1 **Response to reviewer 2: ‘Automated ArcticDEM iceberg detection tool:**
2 **insights into area and volume distributions, and their potential application to**
3 **satellite imagery and modelling of glacier-iceberg-ocean systems’ by Shiggins**
4 **et al.**

5 We would like to thank Till Wagner for their comments which will help to improve the
6 manuscript. Our responses to each of the major and minor comments raised and
7 how we intend to address them for the revised version of the manuscript are outlined
8 below. For this, reviewer comments are copied verbatim in blue, and our response to
9 each is given in black. All line numbers quoted with the prefix L (e.g. L123) refer to
10 those in the original submitted manuscript. All line numbers quoted with the prefix RL
11 (e.g. RL123) refer to those in this response document.

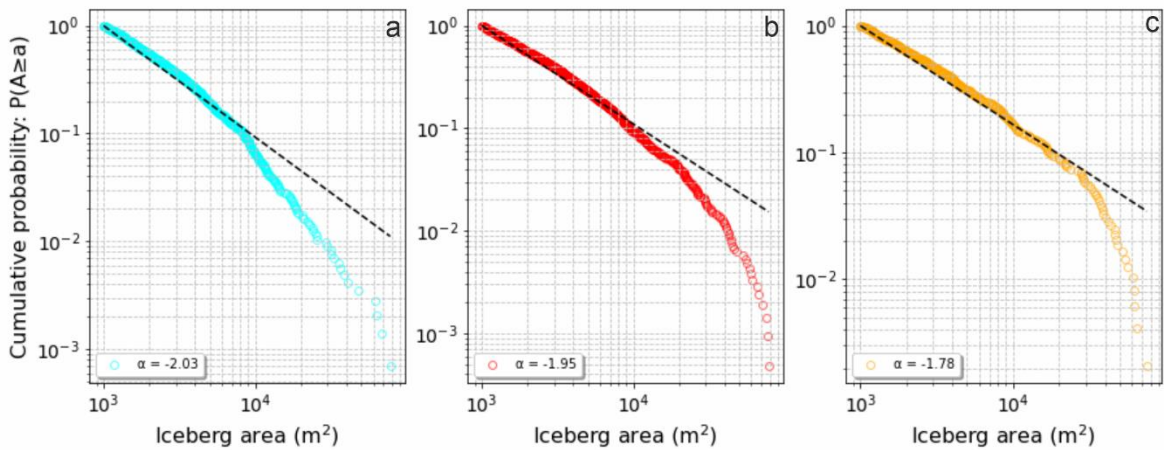
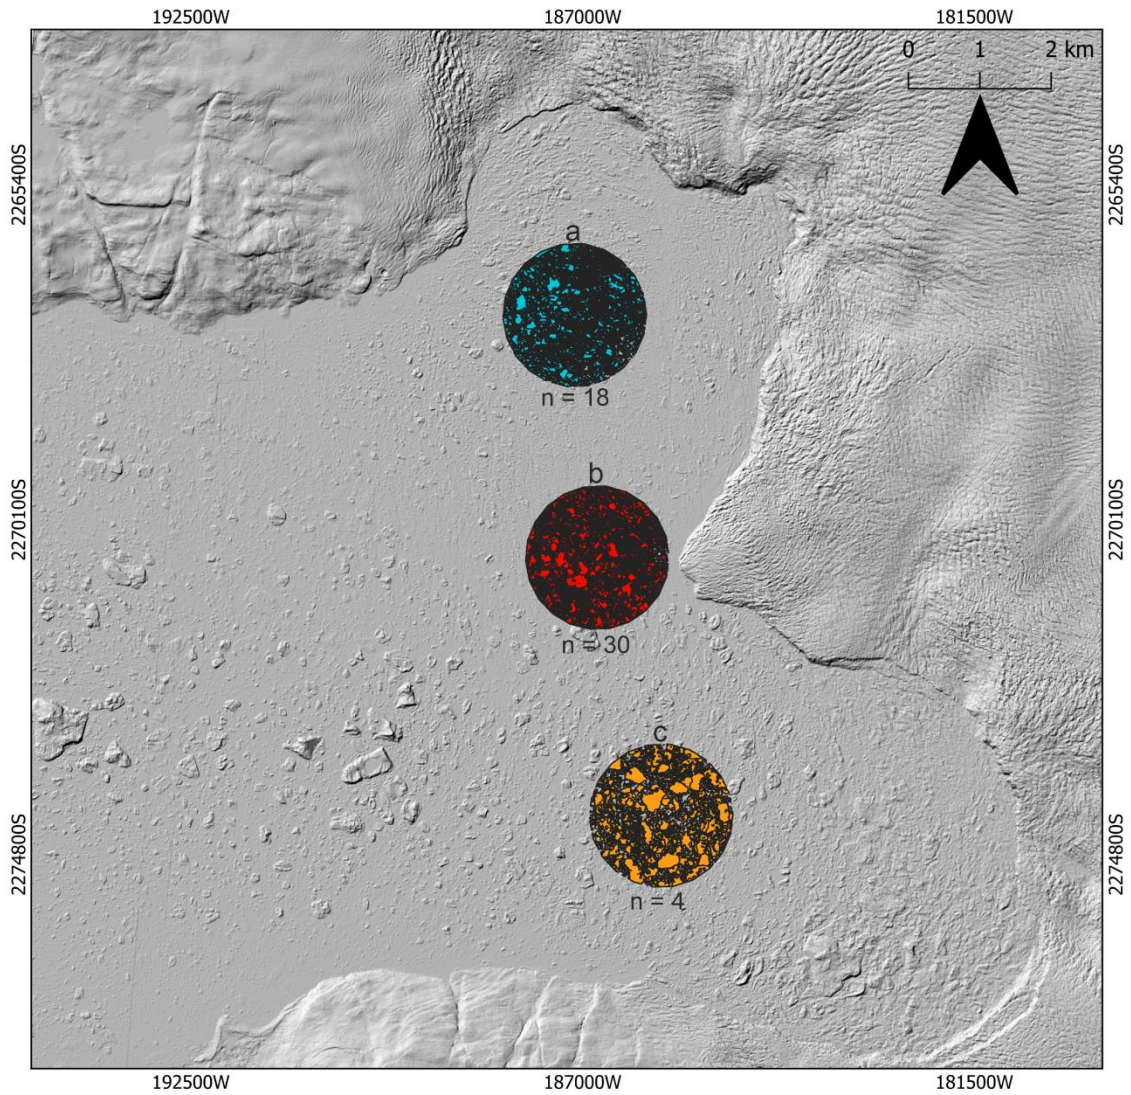
13 1. Availability of ArcticDEMs and picking the right ROI. I was able to run the
14 code on SKJI without much trouble and could also approximately reproduce
15 some of the distributions in the paper (e.g. something similar to those in Fig
16 6). However, when I tried to explore other random glaciers around Greenland
17 I struggled to find ones with any available ArcticDEM scenes. I randomly tried
18 ~10 or so glaciers in different regions and only 2 identified any ArcticDEM
19 scenes (2 scenes each) for the ROIs that I picked. It was not clear to me from
20 the manuscript how exactly to pick the ROIs and I tried to emulate the shapes
21 provided in Fig 1 but realized I had no further knowledge how these were
22 determined. This may be part of the reason why I couldn't detect more DEM
23 scenes. I was also struck by the fact that picking slightly different ROIs in front
24 of SKJI resulted in detecting a different number of scenes and also in

25 somewhat different slopes for the area distributions. I appreciate that a
26 comprehensive account of where ArcticDEM scenes are available may be
27 beyond the scope of this study, but the lack of information in this regard limits
28 the utility of the product. Relatedly, it would be helpful to have some practical
29 guidance of how to draw the ROI polygons to best harness the strengths of
30 the algorithm. Finally, a discussion of how much the results depend on the
31 number of scenes available would be helpful. This could for example be
32 explored by running the analysis on subsets of the SKJI scenes and showing
33 the resulting spread in power law slopes, or similar?

- 34
- 35 • We appreciate the reviewer undertaking comprehensive testing of the tool as
36 it is extremely useful to gain feedback on its usability for those encountering it
37 for the first time. With regards to the definition of the polygon for the ROI,
38 there is a GitHub read.me (<https://github.com/ConnorShiggins/Google-Earth-Engine-and-icebergs>) available which is included in the text of the manuscript.
39 This includes a walkthrough on how to define the ROI. However, after these
40 comments, we will clarify in the text of the revised manuscript that this tutorial
41 exists for users wanting to obtain a dataset (at L169).
 - 42 • With respect to the point raised regarding how slightly different ROI definition
43 impacts results, as suggested by the reviewer we have conducted analysis on
44 3 ROI subsets for SKJI in front of the northern, central and southern regions
45

46 of the glacier (see Draft Figure 3). For the northern branch, results from 18
47 DEMs available returned a power law slope of -2.03, the middle ROI with 30
48 DEMs returned a power law slope of -1.95, and the southern branch subset
49 had 4 DEMs available returning a power law slope of -1.78. Consequently,
50 there is some variation in both image availability and the α value for each
51 section of the fjord. Understanding what is driving this localised variability is
52 poorly understood and certainly deserves detailed study in and of itself.
53 However, given the potential for changing calving styles through time and
54 variation in space of calving dynamics in front of each terminus region, it is not
55 possible to say here whether these differences arise from data availability or
56 differences in fjord/glacier dynamics. Such analysis would require detailed
57 understanding and analysis of individual glacier dynamics and their spatial

58 and temporal variability, which we suggest is beyond the scope of this study.

- 59 • As commented upon by the reviewer and highlighted in the response above,
60 choosing different ROIs can lead to variation in the number of DEMs available
61 for analysis. This is especially noticeable at SJKI as the terminus is over 40
62 km long and ArcticDEM strips rarely cover the entire fjord region. We also
63 note that this is likely to have most significant impact on glaciers with long
64 margins (e.g. SKJI, Humboldt, 79N), and will have less of an impact on termini
65 in narrower (e.g. ~2-10 km wide) fjords. To potentially increase data
66 availability across an ice front, the filter threshold defining the lower limit of
67 ROI coverage can be lowered to allow more DEMs to be taken forward for
68 subsequent analysis (default is 80% or 0.8 in the workflow). This is defined in
69 line 220 of the code with a variable name '*imageAreaCoverage*'. However,
70 doing so may lead to less accurate definition of sea level for each image. To

71 clarify this, we will add discussion of Draft Figure 3 in the main text at L503,
72 and will provide full instructions and caveats as part of the GitHub readme. It
73 should also be noted that the new GUI functionality included in response to
74 Reviewer 1's main comment 2 (RL54) will allow users to get an indication of
75 how much ArcticDEM data may be available for different glaciers across the
76 Arctic region.
